## PISTON REPLACEMENT KIT

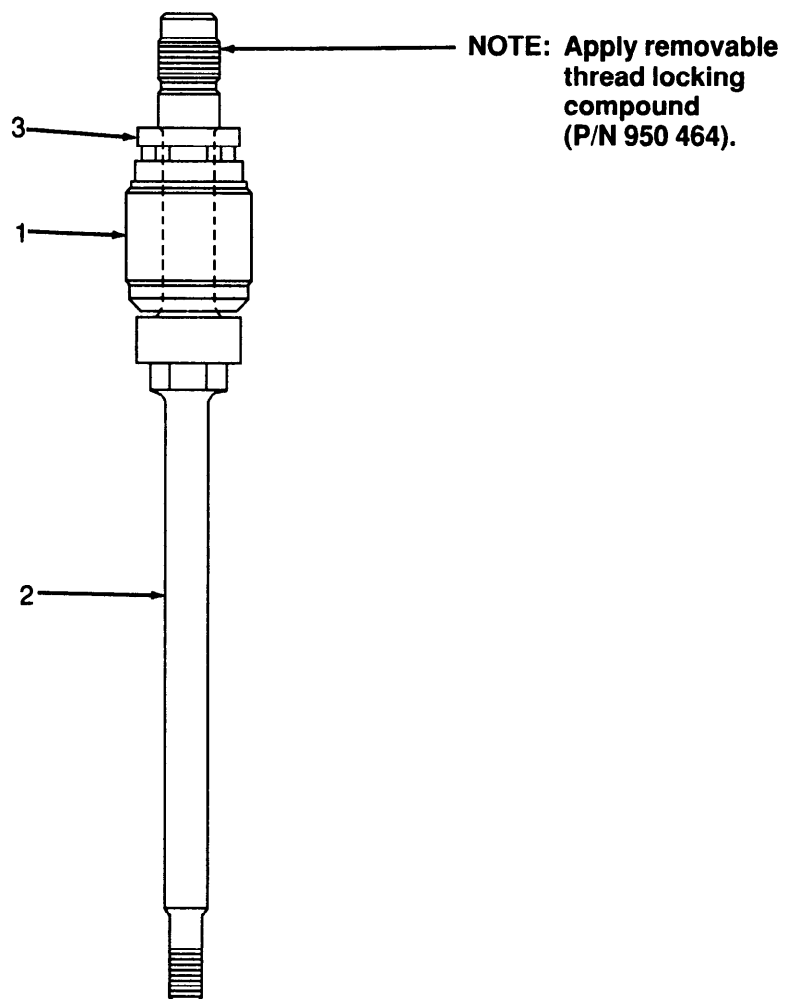
Both pistons PN 133 213 and PN 124 688 have been obsoleted with a new piston (PN 126 853). When either old-style piston is replaced for the first time, the old-style spider (PN 124 691), shovel rod (PN 124 674), and upper check rod (PN 124 673) must also be replaced. Piston replacement kit PN 126 831 contains all the necessary parts to make this conversion. The new items (1-3) are depicted below. After the old-style parts have been replaced, items 1 through 3 can be ordered separately, or replaced as a group, by reordering the kit.
